PRODUCT CHANGE NOTICE

PCN#21-002

MODEL(S) AFFECTED:TCD, TCM, TCP (*see attached for a list of affected models*)**EXTENT OF CHANGE:**

Change of plastic substrate

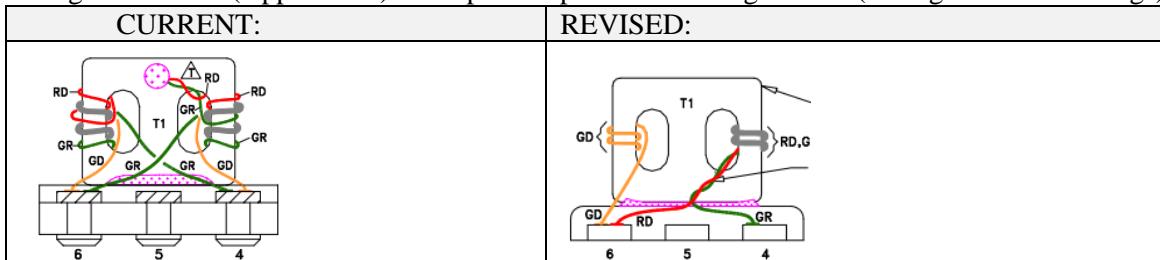
- No change to **Function** (Performance)
- Change to **FIT** (Dimension) – Drop in footprint equivalent, Reduction in total height
- Change to **FORM** (Appearance) - Sample comparative drawings below (Disregard wire windings)

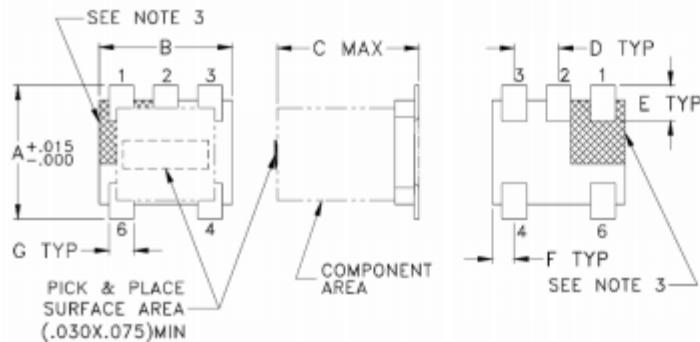
Change of appearance of plastic substrate

- No change in Fit, Form or Function
- Slight change in appearance of the substrate
